Item Name: Fwd Crosstube - High 206L / L1 / L3 / L4

DART AEROSPACE LTD		Work Order:	158289
Description: Crosstube High Fwd (206L)		Part Number:	D206-667-103
Inspection Dwg: D206-667-143 Rev: C		Page 1 of 1

DESIGN	9	DART AEROSPACE LTD	
DRAWN	RF	HAWKESBURY, ONTARIO, CANADA	
CHECKED	CP	DRAWING NO.	REV. C
MFG. APPR.	CP	D206-667-143	SHEET 4 OF 4
APPROVED	CP	TITLE	SCALE
DE APPR.	CP	CROSSTUBE ASS'Y (206L HIGH FWD)	NTS
DATE	08.11.06	COPYRIGHT © 2000 BY DART AEROSPACE LTD THIS DOCUMENT IS PRIVATE AND CONFIDENTIAL AND IS SUPPLIED ON THE EXPRESS CONDITION THAT IT IS NOT TO BE USED FOR ANY PURPOSE OR COPIED OR COMMUNICATED TO ANY OTHER PERSON WITHOUT WRITTEN PERMISSION FROM DART AEROSPACE LTD.

DRAWING NO. D206-667-143	TITLE CROSSTUBE ASS'Y (206L HIGH FWD)	REV. C	DART AEROSPACE LTD ENGINEERING ORDER		D.E.O. NO. D206-667-143-C-1	SHEET NO. SHEET 1 OF 1	SCALE N
DRAWN <i>qp</i>	CHECKED <i>ASS</i>	MFG. APPR. <i>JB</i>	APPROVED <i>MD</i>		DE APPR. <i>TH</i>		
DATE 11.07.15	DATE 11.07.20	DATE 11.07.21	DATE 11/07/21		DATE 11.07.21

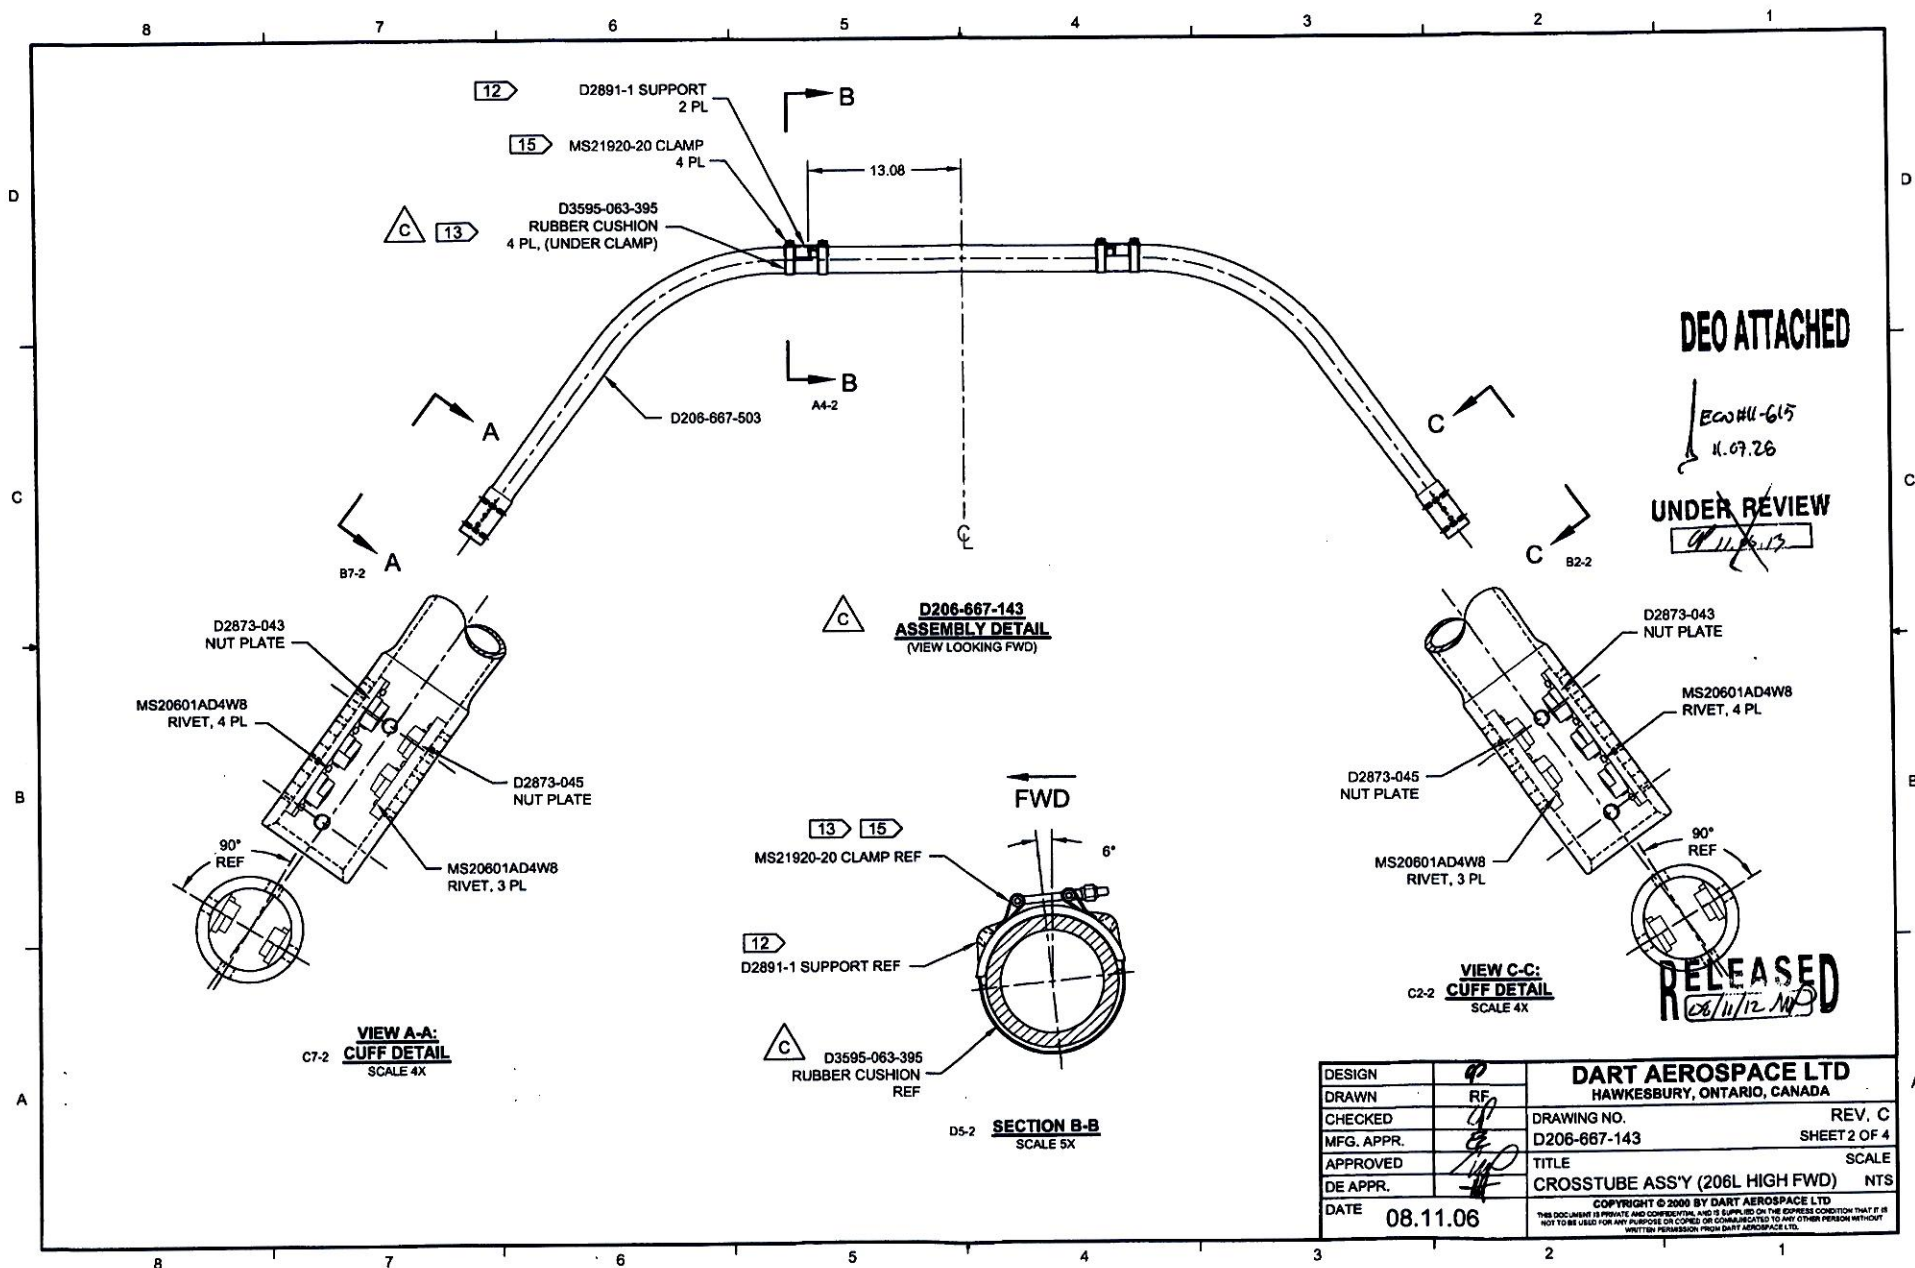
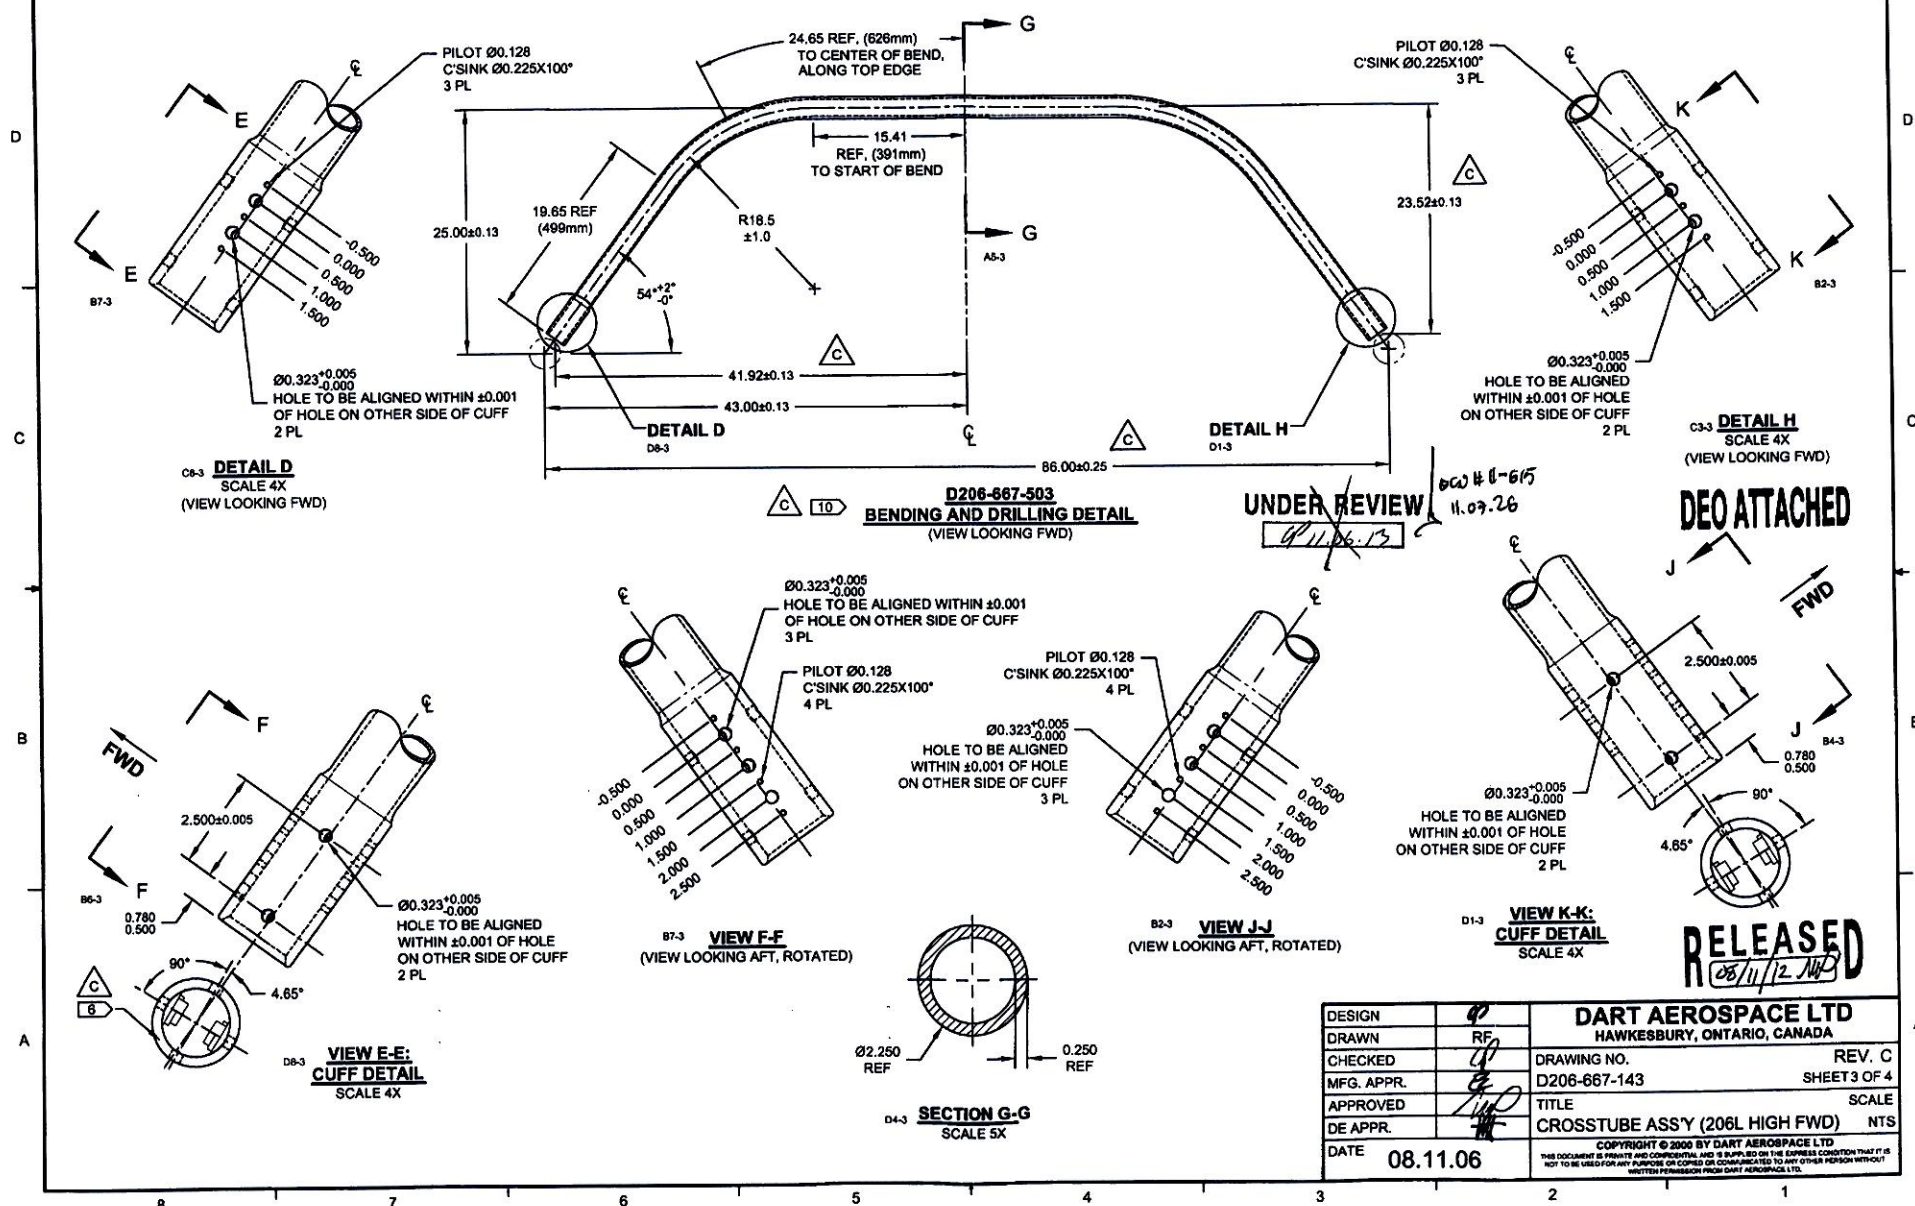
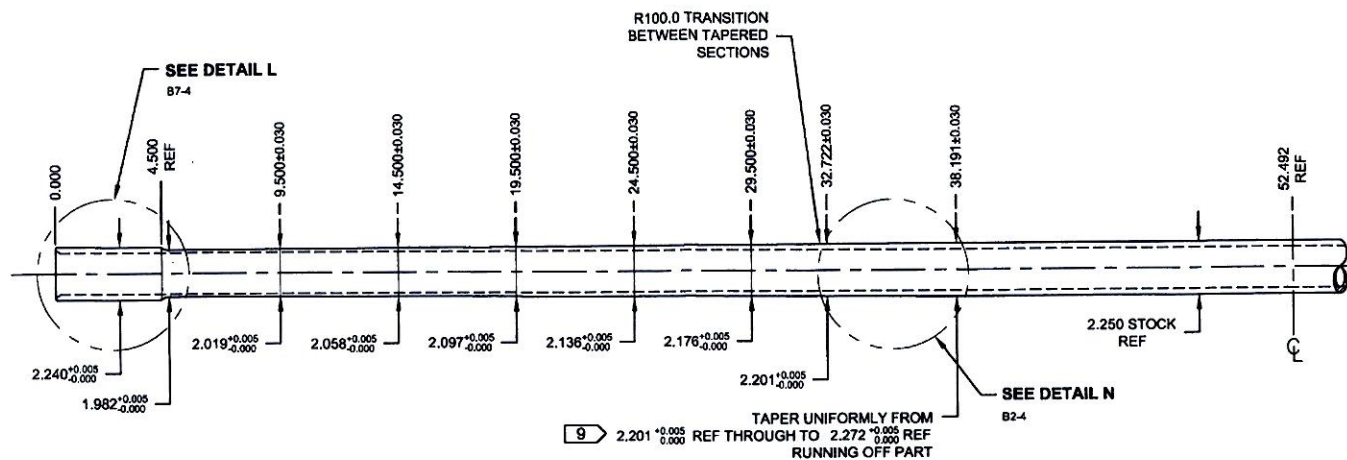
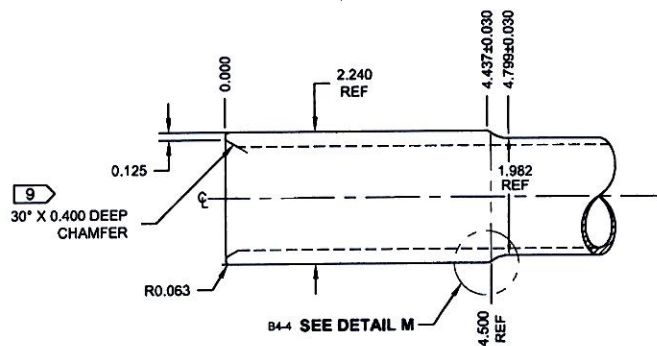
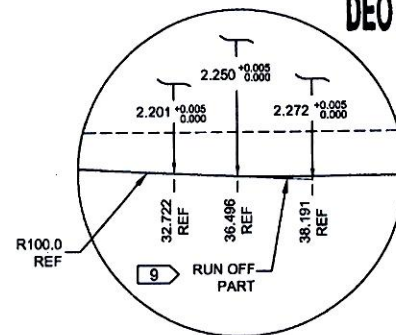
REPLACE MAGNOBOND WITH PROSEAL.

NOTE 12 & 15, SHEET 1 IS AMENDED AS FOLLOWS:

- 12) TO INSTALL D2891-1 SUPPORT: ABRASE MATING SURFACE OF SUPPORT AND CROSSTUBE WITH 180-GRIT SANDPAPER AND REMOVE RESIDUE WITH MEK (OR EQUIVALENT). APPLY A 0.04" TO 0.07" THICK LAYER OF PROSEAL 890 CLASS B-2 (OR AMS-S-8802 CLASS B-2) SEALANT TO MATING SURFACE OF SUPPORT.
- 15) TORQUE CLAMPS 80 TO 100 IN-LB. ENSURE AT LEAST 1.5 THREADS SHOWING IN SAFETY AND THAT NUT HAS NOT BOTTOMED-OUT AFTER TORQUING. **PRIOR TO PACKAGING, RE-CHECK TORQUE ON CLAMPS AFTER PROSEAL 890 SEALANT HAS CURED FOR 72 HOURS.**

DRAWING NO. D206-667-143	TITLE CROSSTUBE ASS'Y (206L HIGH FWD)	REV. C	DART AEROSPACE LTD ENGINEERING ORDER		D.E.O. NO. D206-667-143-C-2	SHEET NO. SHEET 1 OF 1	SCALE NTS
DRAWN AJS	CHECKED	MFG. APPR.	APPROVED	DE APPR.			
DATE 12.08.02	DATE 12.08.02	DATE 12.08.02	DATE 12.08.02	DATE 12.08.02

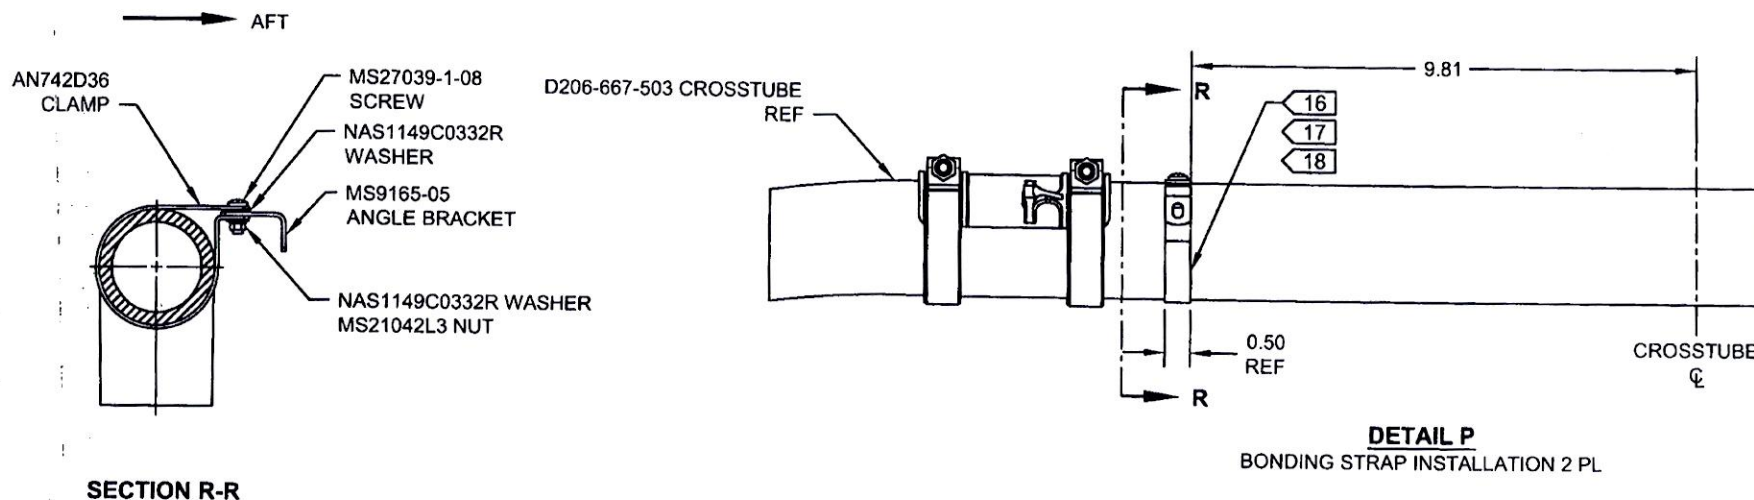
ADD ELECTRICAL GROUNDING STRAP

ITEM	QTY -143	PART NUMBER	DESCRIPTION
1	X	D206-667-143	CROSSTUBE ASSEMBLY (206L HIGH FWD)
10	2	AN742D36	CLAMP
11	2	MS9165-05	ANGLE BRACKET
12	2	MS21042L3	NUT (OR MS21042-3)
13	2	MS27039-1-08	SCREW
14	4	NAS1149C0332R	WASHER (OR AN960C10L)
